**City of San Jose's
Draft Environmental Impact Report for
The Three Creeks Trail Pedestrian Bridge Project**

CSJ Proj. No: PP13-085

Subj: My Public Comments

RE: PP13-085 ~ Public Draft of the EIR for the Three Creeks Trail Pedestrian Bridge

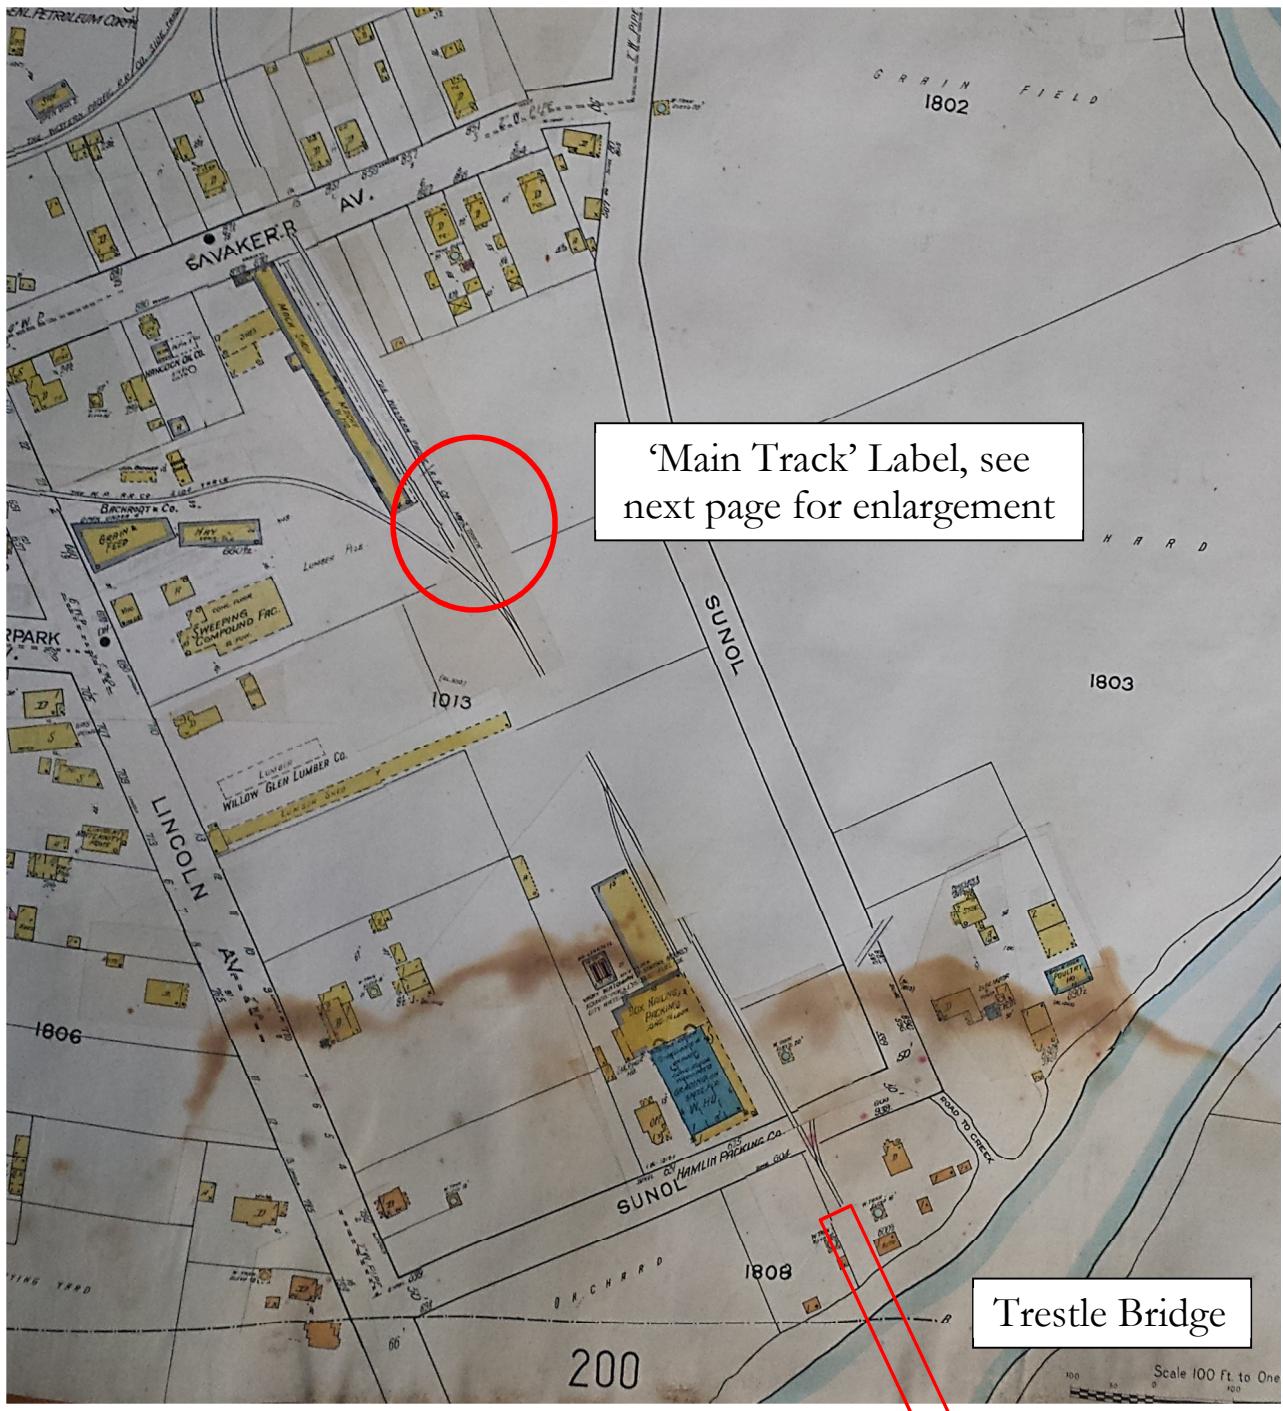
A. The Evaluation of Aesthetics is subjective & the Facts don't support the Conclusion:

1. Item 3.1.3 Environmental Impacts – states that Los Gatos Creek is preserved in a relatively natural state with a dense corridor of riparian vegetation and generally considered to be a Scenic Amenity. Some community members consider the "Trestle Bridge to be of Visual Interest that evokes the early period in Willow Glen's Development, ties in with the historic architecture elsewhere in the community and is a visual reminder of the early railroad history in the area."

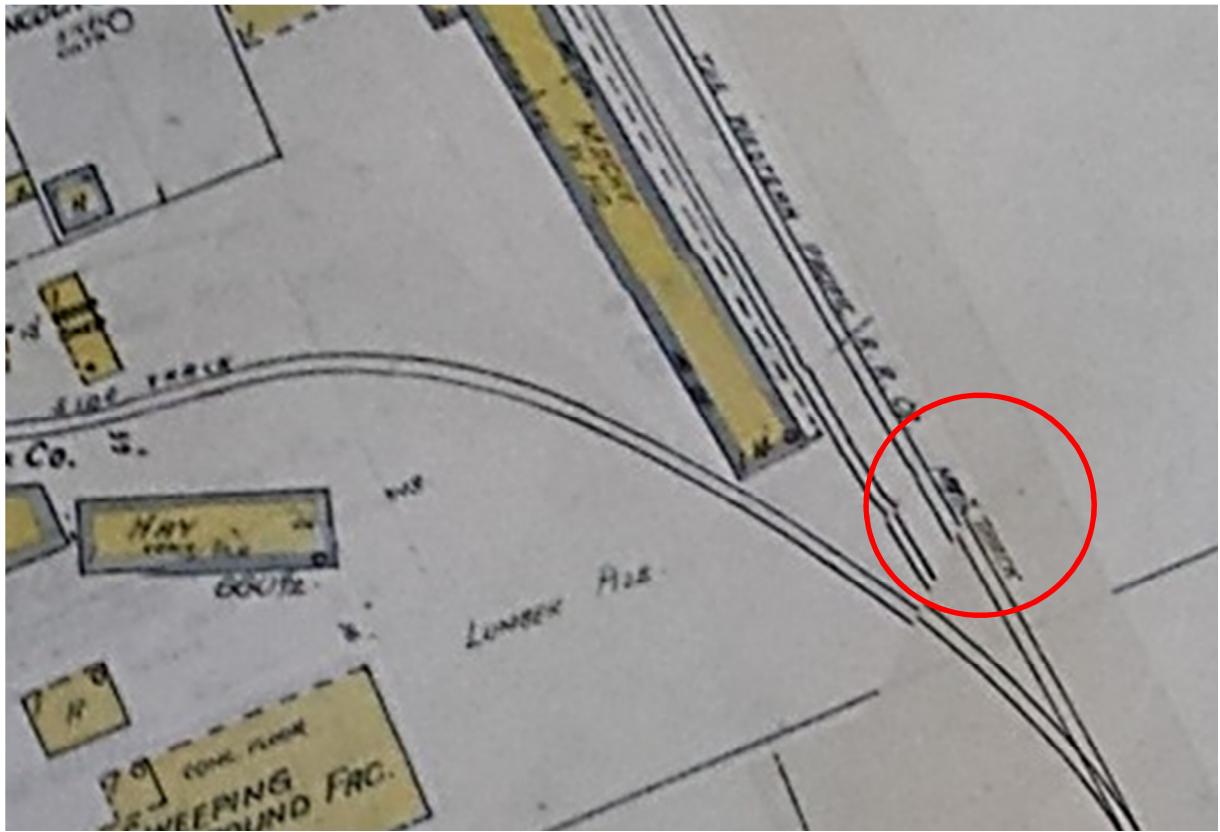
3. The Report also states that this Bridge is part of a 'Secondary' Line. This is not correct. According to the 1932 Sanborn Fire Insurance Maps in San Jose's MLK Library label this section of the RR as a 'Main Track'. Sanborn Maps did not show all the RR Information because they were for Insurance purposes. Refer to the following Map:

(It took less than ½ hour to find this Map. Why isn't this referenced in the Report?)

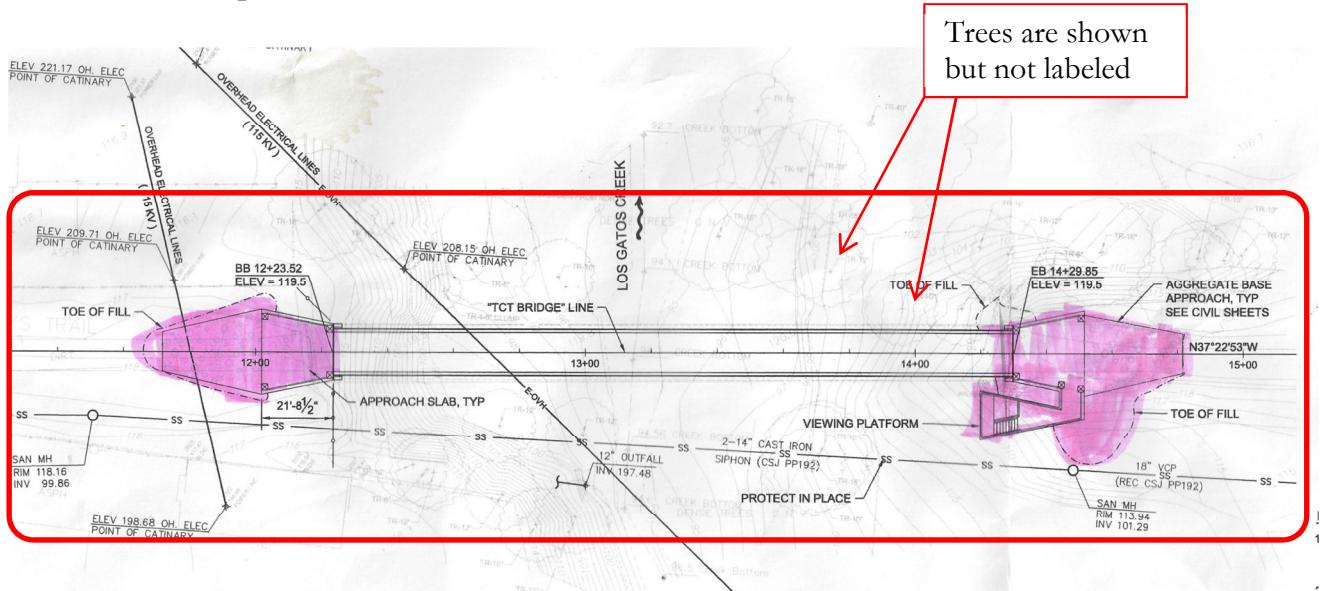
7. The Evaluation Criteria – does the proposed project "Substantially degrade the existing visual character or quality of the site and its surroundings" describes that the new bridge will be more visual to the people on Coe and Lonus Streets, as if that's a good thing. Why? It is stated that this is a 'natural riparian corridor'. As such, shouldn't the trees be the dominant element?

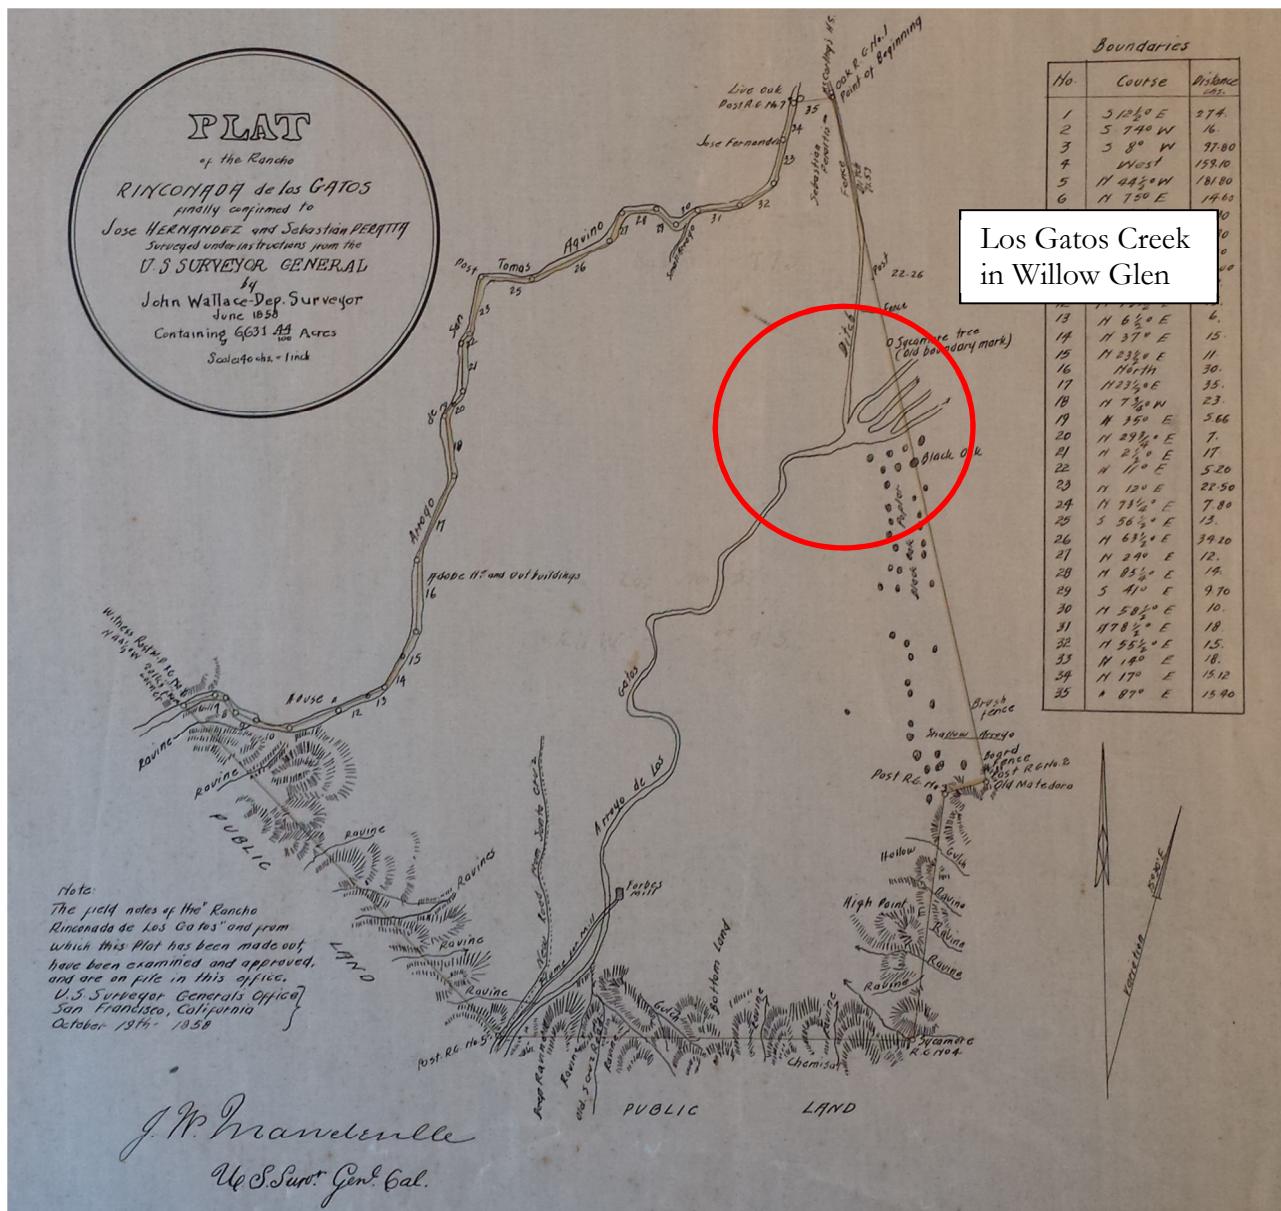
1. Page 3-28 – item 3.4.1.2, National Register of Historic Places Eligibility Criteria, Item A and C are to be applied to the evaluation of the Trestle Bridge. Item A – [Objects] that are associates with events that have made a significant contribution to the broad pattern of our history. Item C - [Objects] that embody the distinctive characteristics of a type, period or method of construction.
2. Appendix F, page 15 discusses the development of Willow Glen. It states that this area was “incorporated as a City in 1927, in a large part because of the disagreement with the City of San Jose about where the SPRR should build its north-south alignment.”, San Jose sought to force SPRR to move the line, which would bifurcate Willow Glen.
3. The Willow Glen Trestle Bridge, although not part of this original north-south line, it is the only structure left from that time period.
